## NOTICE OF VIOLATION

On May 8, 2025, Energy Safety conducted an inspection of Liberty Utilities' WMP initiatives in the vicinity of the city of Olympic Valley, California. The inspection report is enclosed herewith. Energy Safety found the following violation(s):

# INSPECTION REPORT

Item1GImg1: Overall Pole

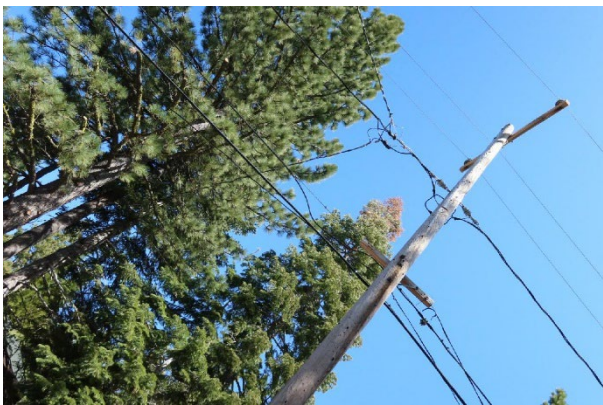
On pole ID 81315, Grid Hardening ID d082c49c-b01f-4e34-929a-8d171ee00dc7 at 1687-1783 Sandy Way, Olympic Valley, CA, 96146, USA, 39.2010571701618, -120.232169340005, the inspector observed that the tree attachment was present on the tree. The inspector's observation is documented in Violation 1 photographs, which are attachments to this report. Photo numbers Item1IA1Img1, Item1IA1Img2 depict incomplete removal of a tree attachment. In the 2024 Q3 Quarterly Data Report submission, LU reported that work on 8.1.2.12 – Tree attachment removals were completed at this location.

1. A tree attachment was observed on the tree at this location.
2. The conductor is present at the tree attachment point.
3. A new pole with modern materials and specifications was not observed at this location.
